# AGENDA

A. **SHADOWRIDGE:** The request is to create 8 lots from the east 60' of the south 600' of the SE1/4 NE1/4 Sec. 32, T 18N, R. 1E, SM, AK, U.S. Gov. Lot 1 and N1/2 of U.S. Gov. Lot 5 Sec. 32, T.18N. R.1E. SM, AK, Except therefrom the west 660' of U.S. Gov. Lot 1 and U.S. Gov. Lot 6 and N1/2 of U.S. Gov. Lot 7 Sec.33, T.18N, R.1E. SM, AK excepting therefrom a portion of U.S. Gov. Lot 6 described in 2021-017480-0, to be known as **Shadowridge**, containing 68.81 acres +/- . All proposed lots will access N. Ridgewater Street, which is not certified or maintained by the Borough. Petitioner to construct and dedicate a temporary turnaround. Petitioner is requesting a variance from MSB 43.20.140 for conformance with the Subdivision Construction Manual regarding tangent between horizontal curves. The property is located west of Finger Lake, southeast of Finger Lake Elementary School and directly west and east of N. Ridgewater Street (Tax ID # 9222000T00A/U001-17&99) lying within Sections 32 & 33, Township 18 North, Range 01 East, Seward Meridian, Alaska. In the North Lakes Community Council and in Assembly District #6. **\*\*This case was continued from the November 17, 2023 publi

WASILLA, ALASKA  
 SHADOWRIDGE  
 PLAN AND PROFILE - DESIGN  
 N. RIDGEWATER ST.

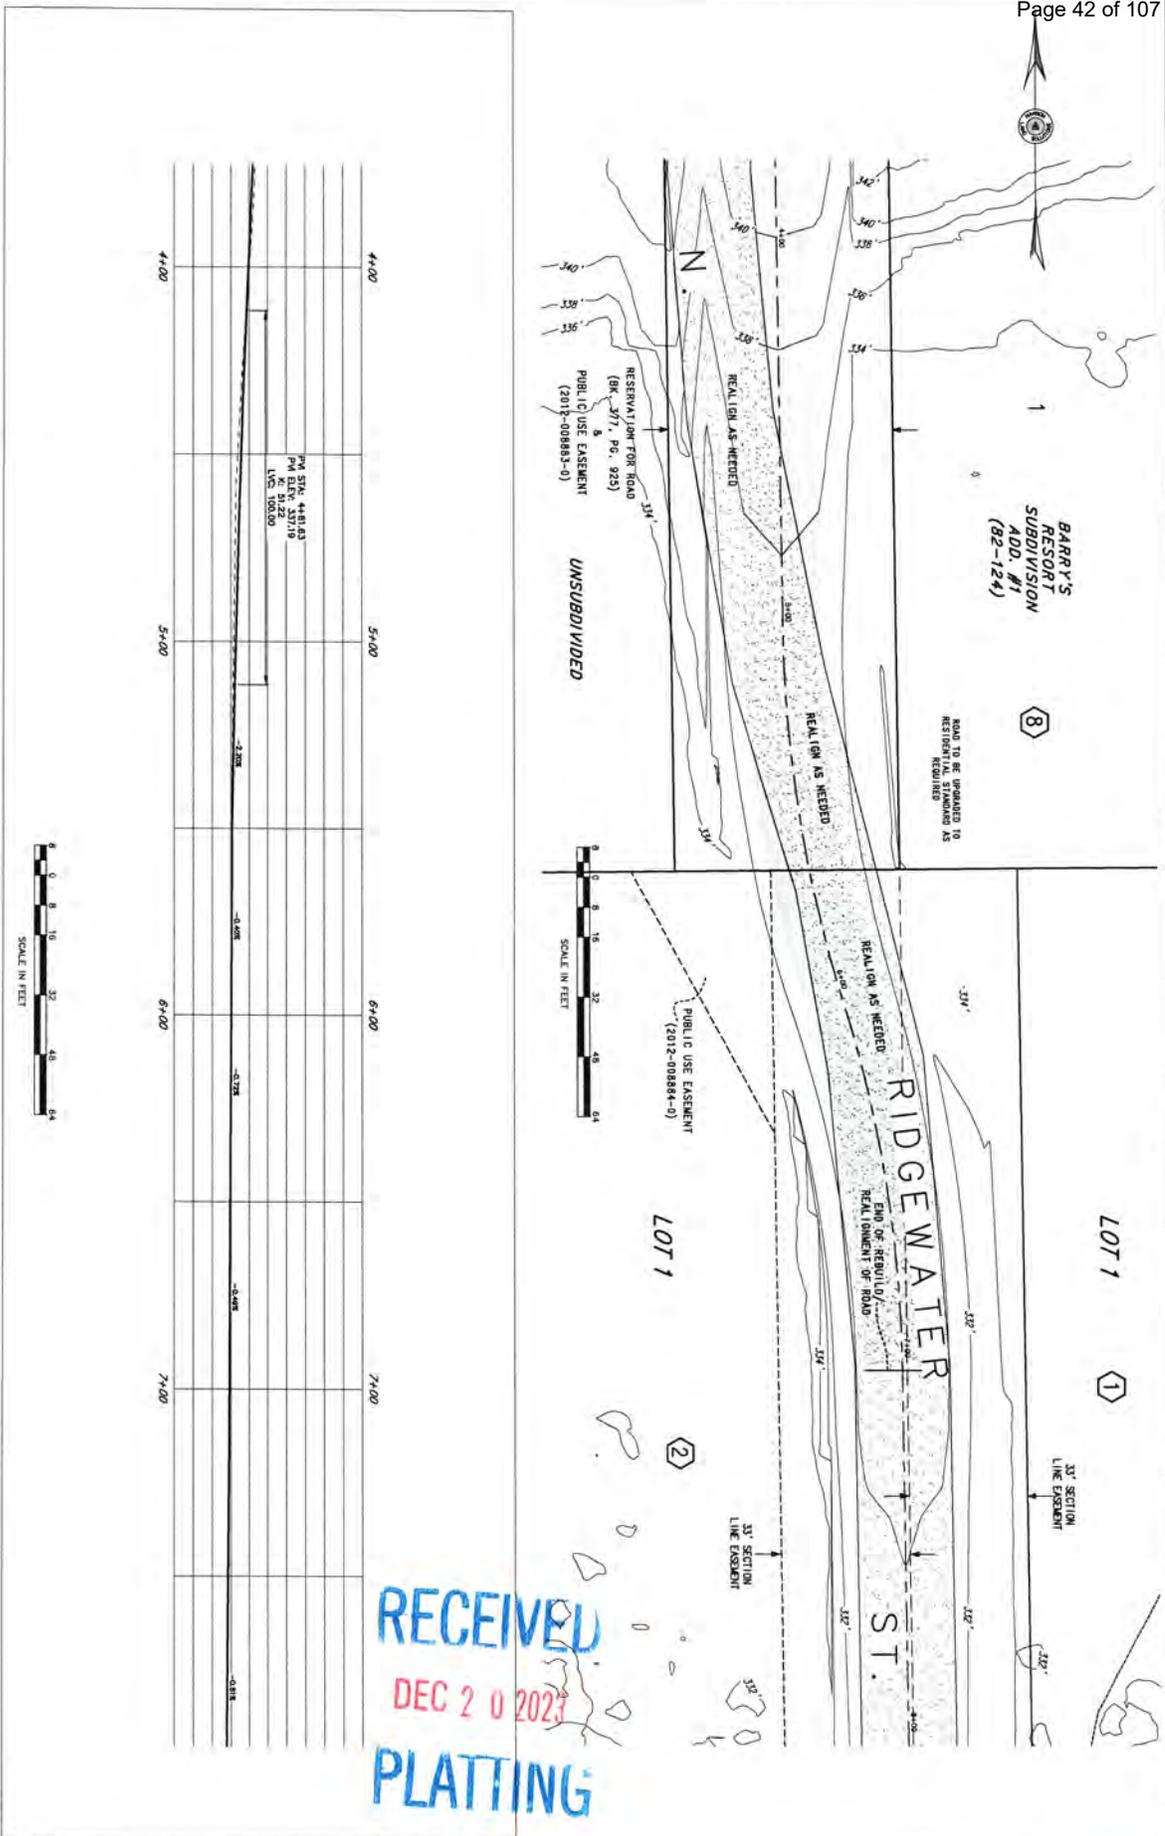
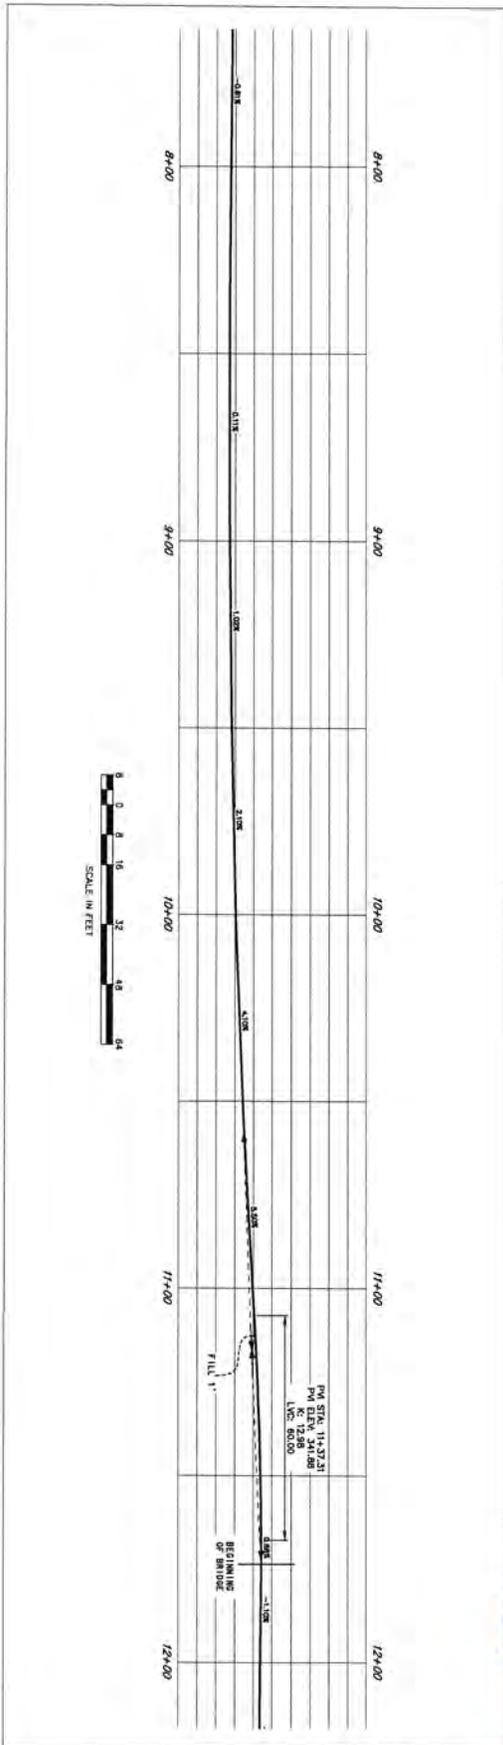
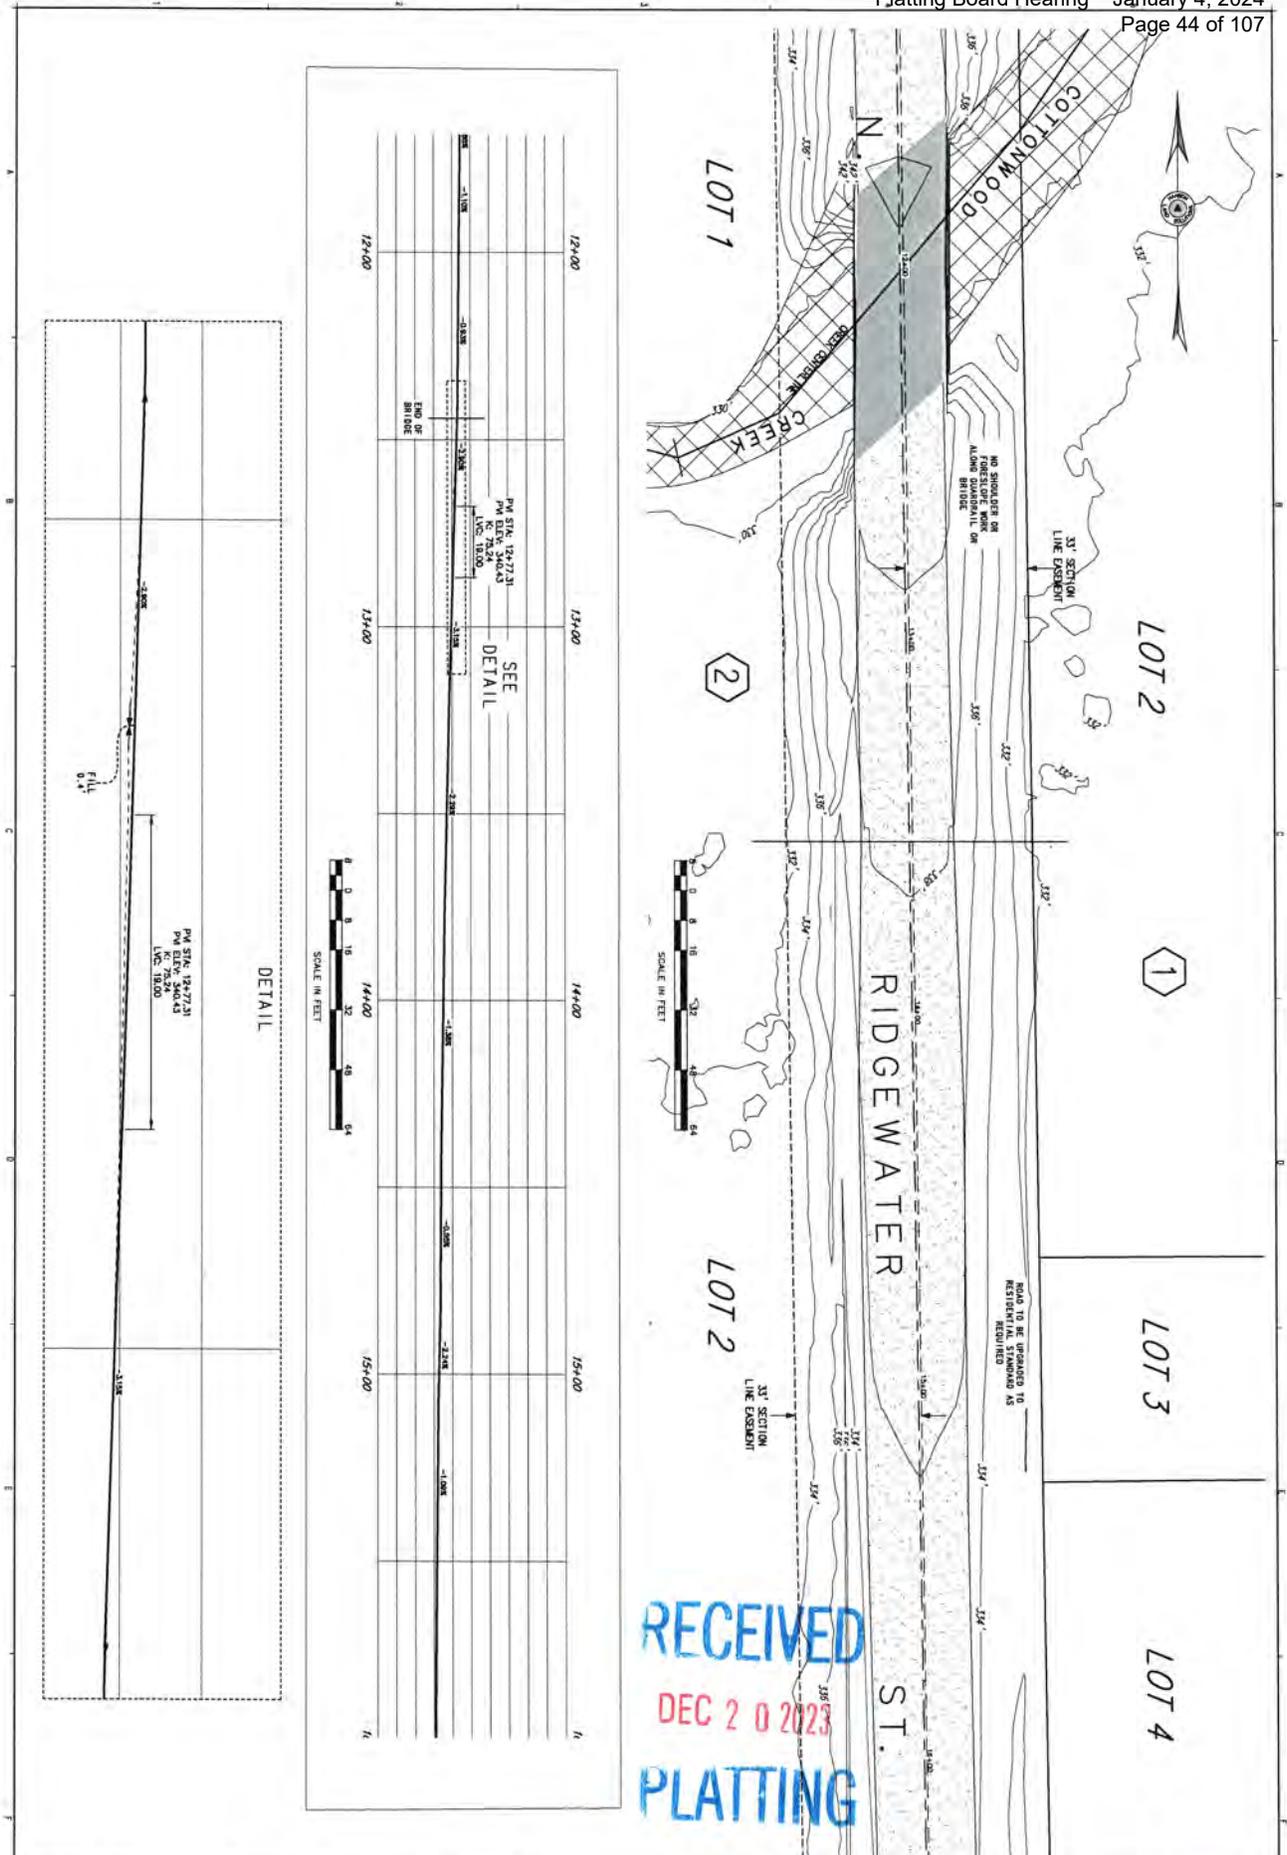
Multiple revisions of plan drawings have been submitted. It is unclear to PD&E, which plans are current. Submit up-to-date road and bridge construction plan and profile drawings as one combined set for PD&E review. The final plans should be included in the platting board packet.

From sta. 2+00 to 5+00 along the western ROW boundary and around 5+75 along the eastern ROW boundary the roadway plan shows the road veering close to the ROW. Taking into account the proposed 30" ditches, this would mean construction would not be contained within the ROW. Redesign the road so that all improvements are contained within the ROW or alternatively, obtain additional ROW. Add horizontal alignment information including curve and tangent data to the plans. Thank you for supplying the updated drawings. Per SCM Table A1-1 the minimum horizontal curve radius is 225'. Please add horizontal alignment information including curve and tangent data to the plans so that PD&E may review the design prior to a variance to curve radius being granted.

In response to the DPW comment the grade brakes from the bridge approaches to the deck grade vary from 4.5% at the southeast corner to 11% at the northeast corner. These are both concrete surfaces that appear to have been poured in place.

Road curves meeting the curve requirements to be certified as Residential Sub-collector.
